**Subject: Water and Waste Water System Improvements
North Central Ag Park Expansion – Water System Improvements
2011, Phase B: Water Treatment Plant Section 1: High Service
Pumps and Stand-by Power – Change Order #5 – Rice Lake
Construction**

SUMMARY OF CHANGE ORDER #5

**MAIN FLOOR
REMOVAL PLAN**

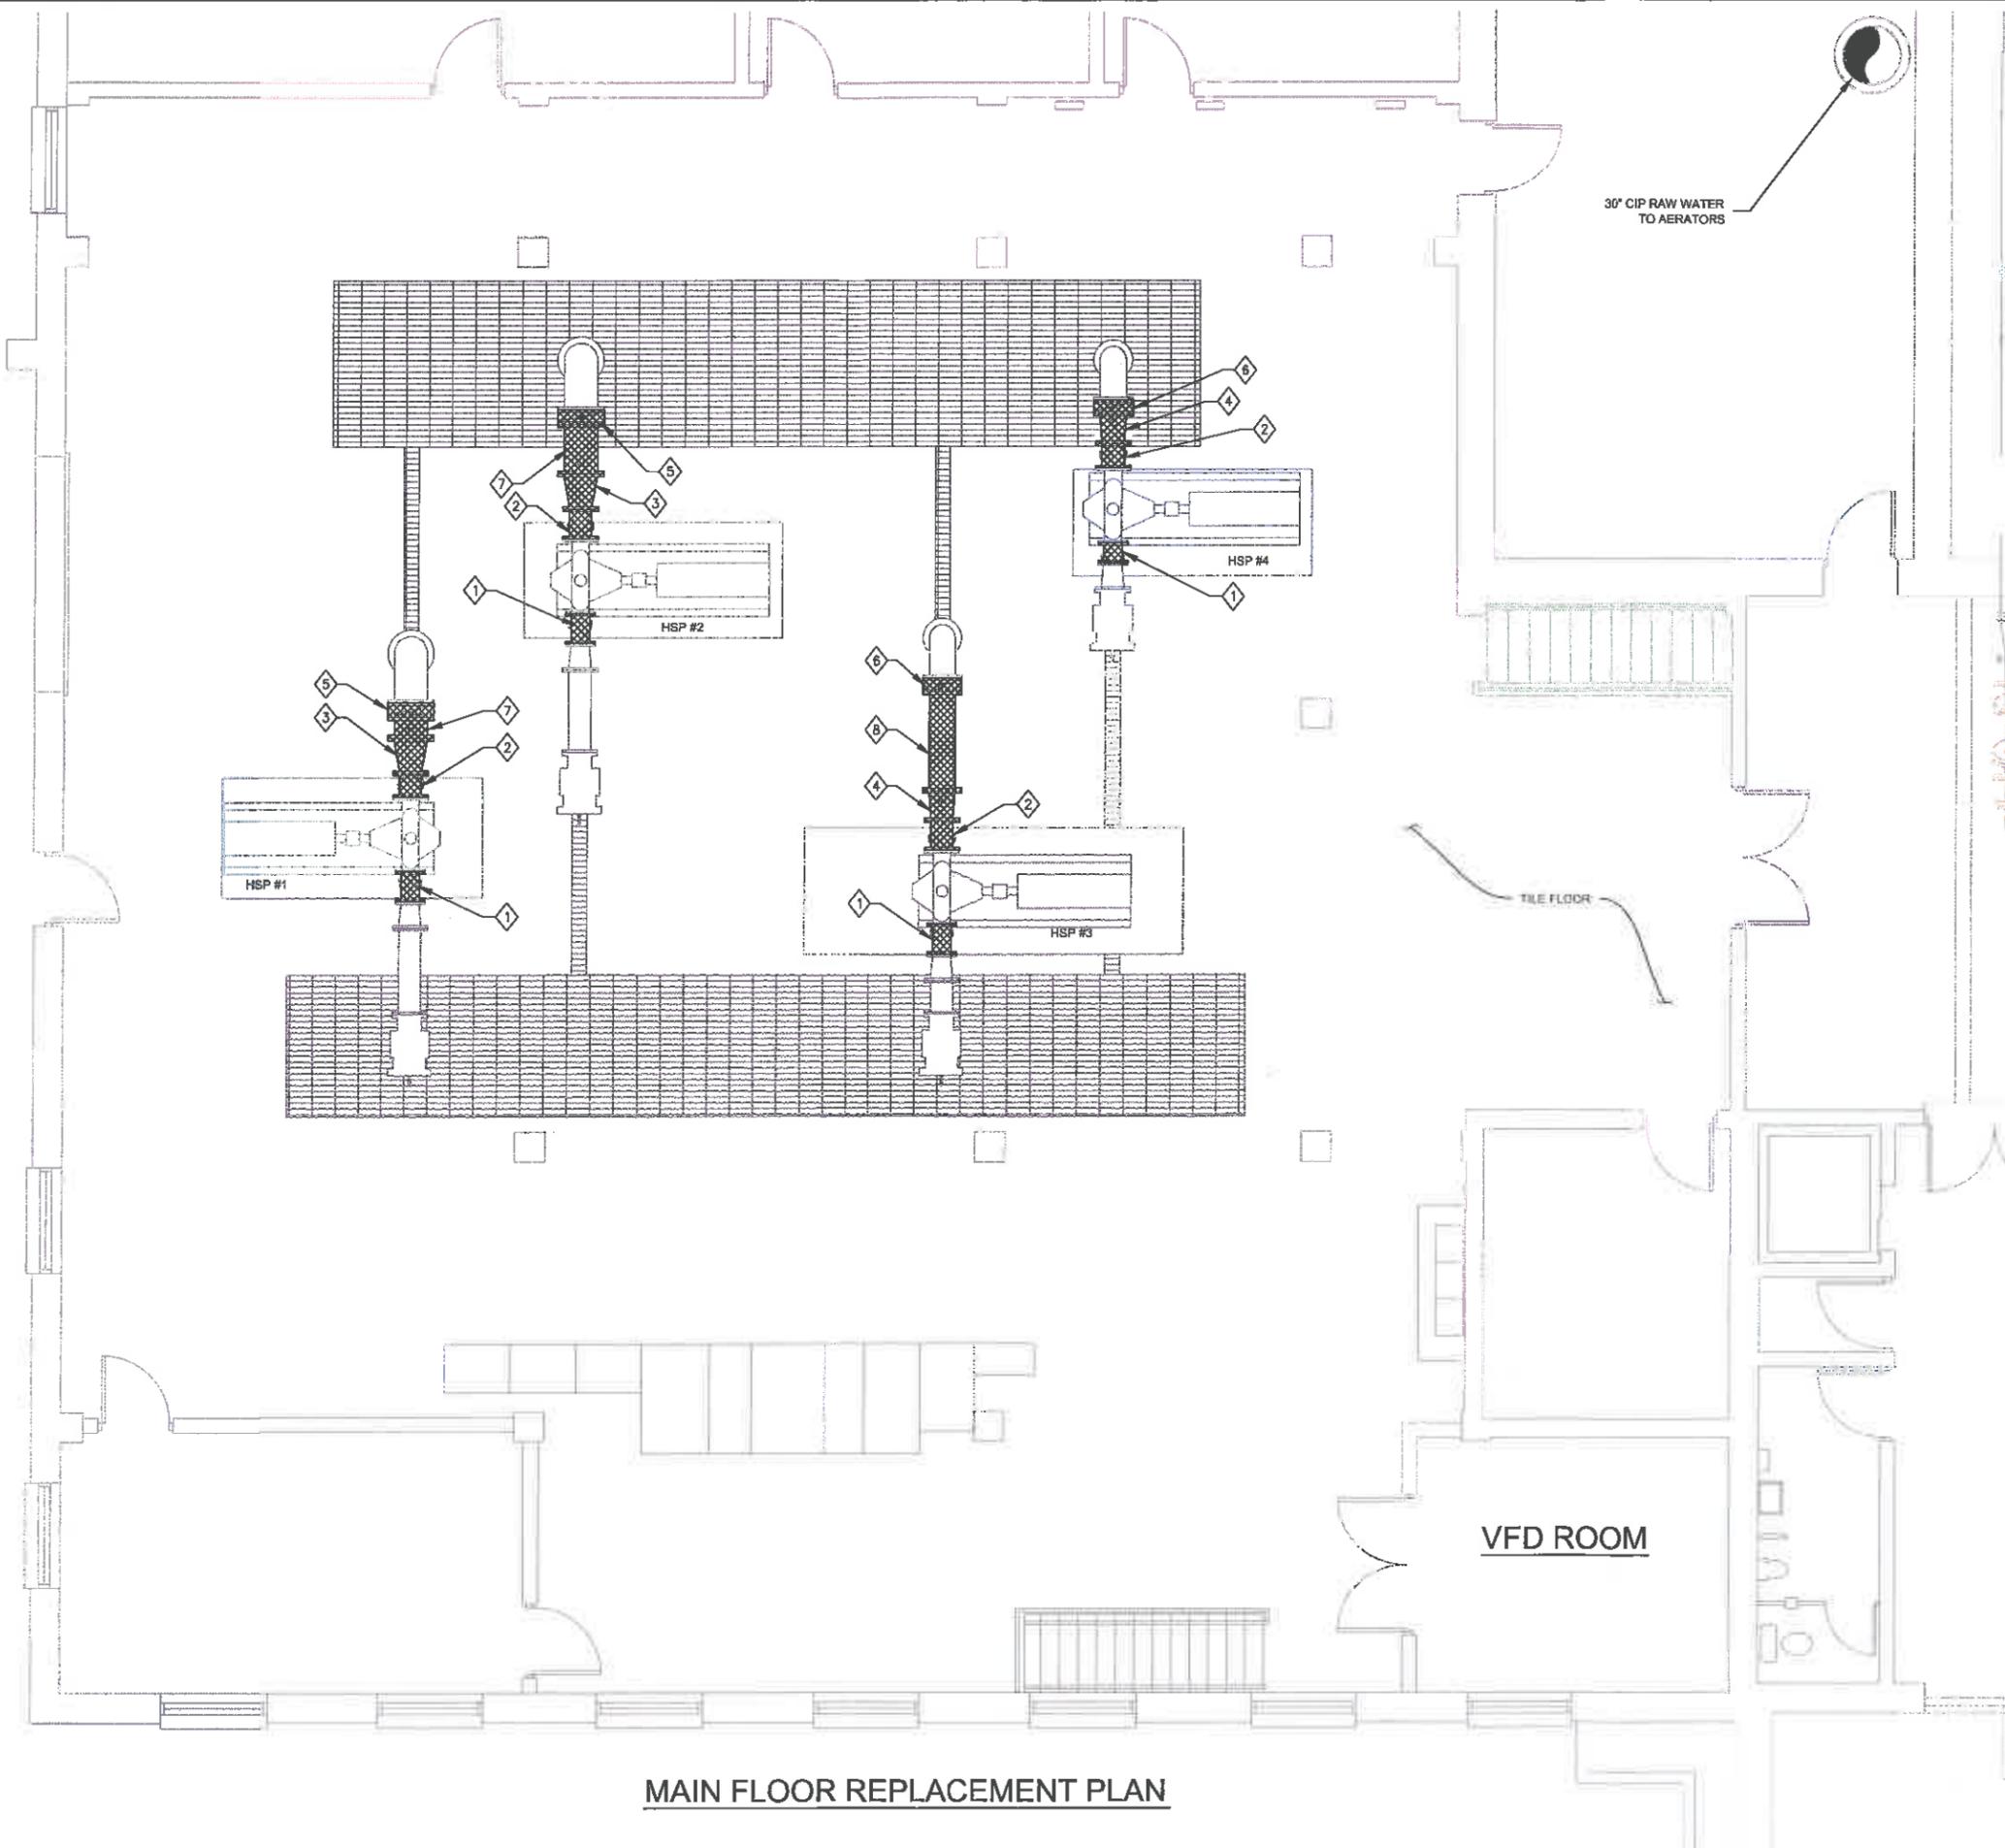
- 1 REMOVE EXISTING 10" FLANGED COUPLING ADAPTER. SAVE FOR RE-USE.
- 2 REMOVE EXISTING 12" FLANGED COUPLING ADAPTER.
- 3 REMOVE EXISTING 18"x12" CONCENTRIC REDUCER.
- 4 REMOVE EXISTING 14"x12" CONCENTRIC REDUCER.
- 5 REMOVE EXISTING 18" BUTTERFLY VALVE. SAVE FOR RE-USE.
- 6 REMOVE EXISTING 14" BUTTERFLY VALVE. SAVE FOR RE-USE.
- 7 KEEP EXISTING 18" DI PIPE WITH TAPS. FOR RE-USE.
- 8 KEEP EXISTING 14" DI PIPE WITH TAPS. FOR RE-USE.

MAIN FLOOR REPLACEMENT PLAN

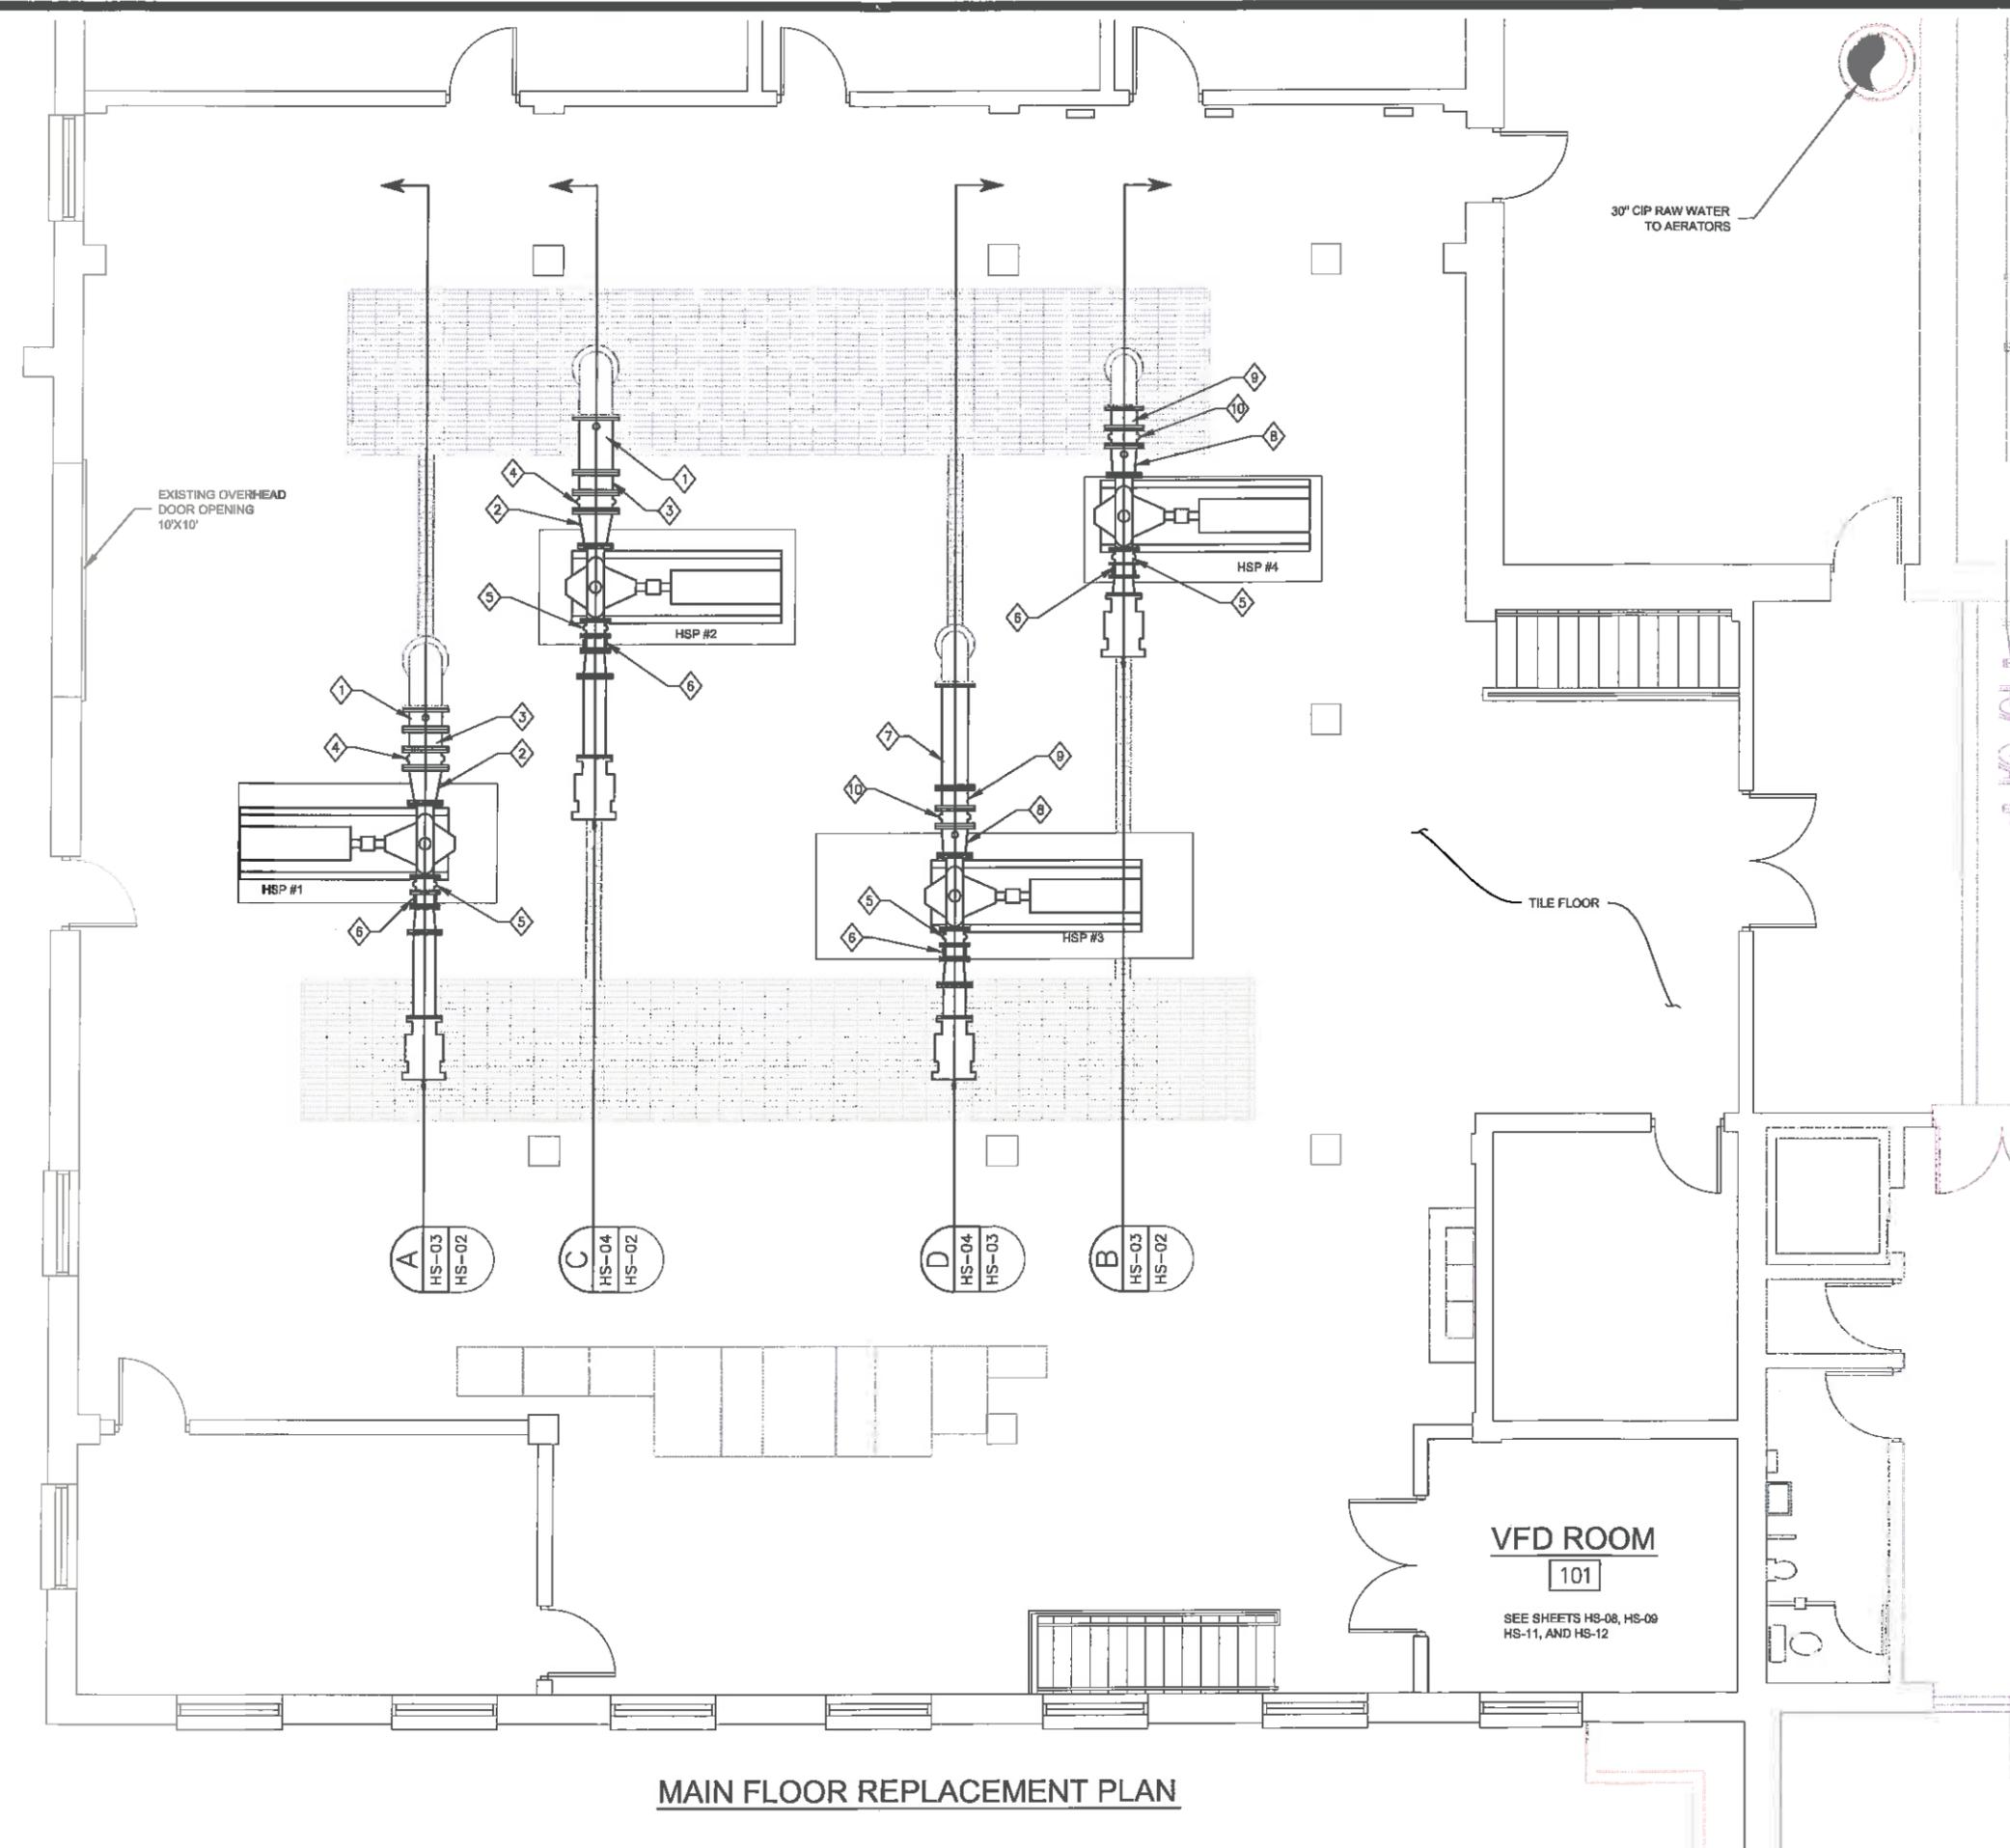
- DIAMOND NOTES**
- ① EXISTING 18" DI PIPE WITH THREADED TAPS. RE-INSTALLED DIRECTLY TO 18" 90° BEND.
 - ② 18"x12" ECCENTRIC REDUCER.
 - ③ NEW 18" DI SPOOL
 - ④ 18" RUBBER EXPANSION JOINT. PROCO STYLE 231 FA, OR EQUAL. (TYP. OF 2)
 - ⑤ 10" RUBBER EXPANSION JOINT. 250# BOLT PATTERN. PROCO STYLE 231 FA, OR EQUAL. (TYP. OF 4)
 - ⑥ RE-INSTALL EXISTING 10" FLANGED COUPLING ADAPTER AT REDUCED LENGTH.
 - ⑦ EXISTING 14" DI PIPE RE-INSTALLED DIRECTLY TO 14" 90° BEND.
 - ⑧ 14"x12" ECCENTRIC REDUCER WITH 3/4" THREADED TAPS ON SIDE AND TOP. RE-INSTALL EXISTING PRESSURE GAUGE AND AIR RELEASE VALVE.
 - ⑨ NEW 14" DI SPOOL
 - ⑩ 14" RUBBER EXPANSION JOINT. PROCO STYLE 231 FA, OR EQUAL. (TYP. OF 2)

REPLACEMENT SECTIONS

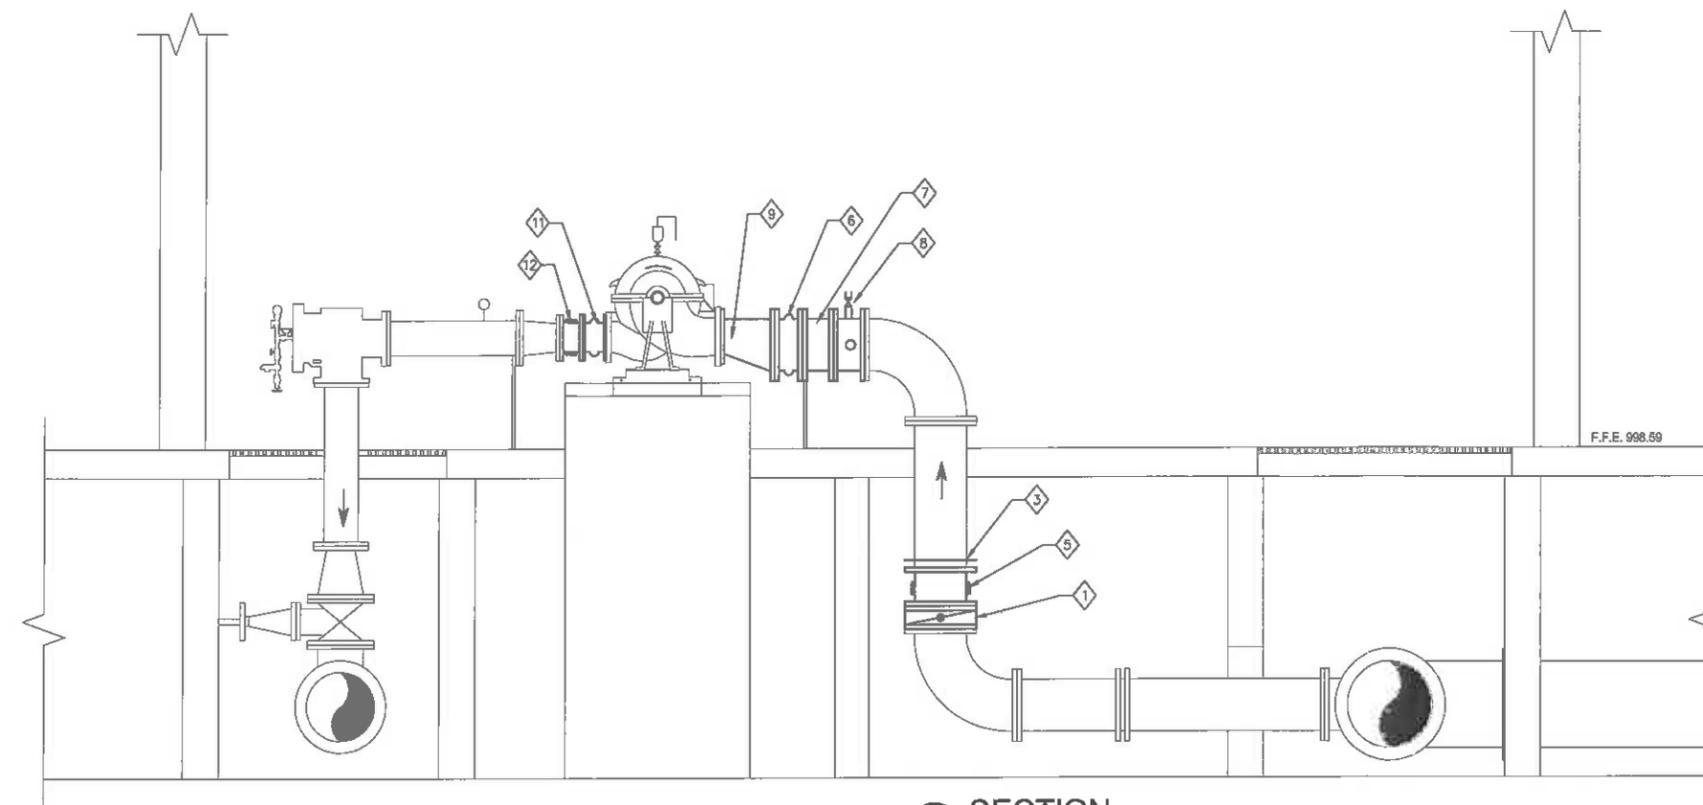
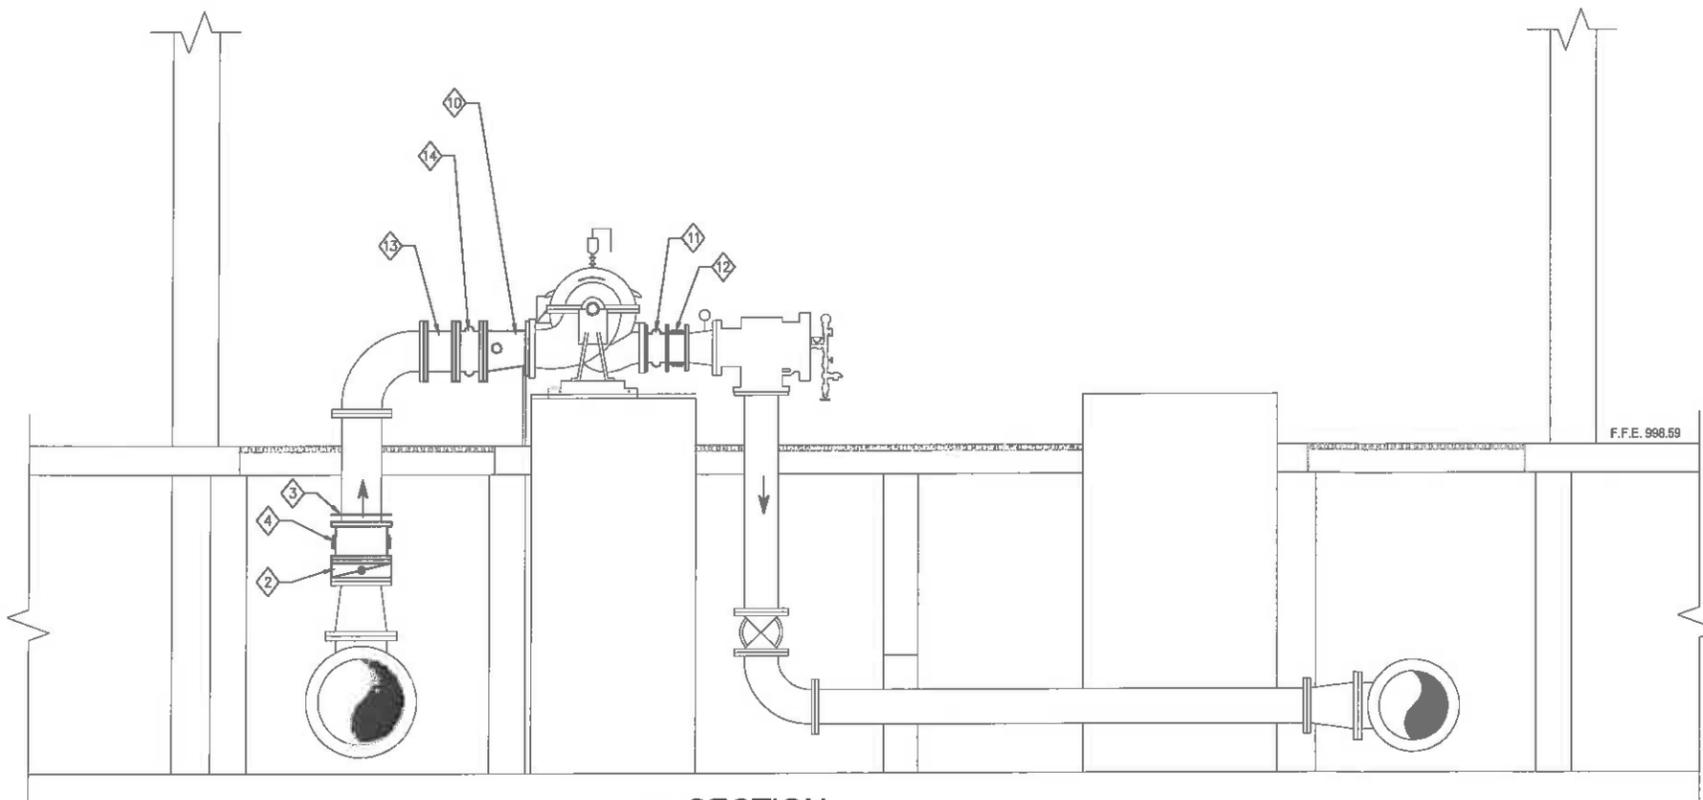
- 1 RE-INSTALLED 18" BUTTERFLY VALVE. INSTALL WITH STEM PARALLEL TO N-S PLANE.
- 2 RE-INSTALLED 14" BUTTERFLY VALVE. INSTALL WITH STEM PARALLEL TO N-S PLANE.
- 3 CUT PIPE AT NECESSARY LOCATION TO INSTALL COUPLING.
- 4 14" FLANGED COUPLING ADAPTER.
- 5 18" FLANGED COUPLING ADAPTER.
- 6 NEW 18" RUBBER EXPANSION JOINT. PROCO STYLE 231 FA, OR EQUAL.
- 7 NEW 18" DI SPOOL.
- 8 EXISTING 18" DI PIPE WITH THREADED TOPS RE-INSTALLED DIRECTLY TO 18" 90° BEND.
- 9 16"x12" ECCENTRIC REDUCER.
- 10 14"x12" ECCENTRIC REDUCER WITH 3/4" TAPS ON TOP AND SIDE. RE-INSTALL EXISTING PRESSURE GAUGE AND AIR RELEASE VALVE.
- 11 10" RUBBER EXPANSION JOINT. PROCO STYLE 231 FA, OR EQUAL. 250# BOLT PATTERN.
- 12 RE-INSTALL EXISTING 10" FLANGED COUPLING ADAPTER AT REDUCED LENGTH.
- 13 NEW 14" DI SPOOL.
- 14 NEW 14" RUBBER EXPANSION JOINT. PROCO STYLE 231 FA, OR EQUAL.
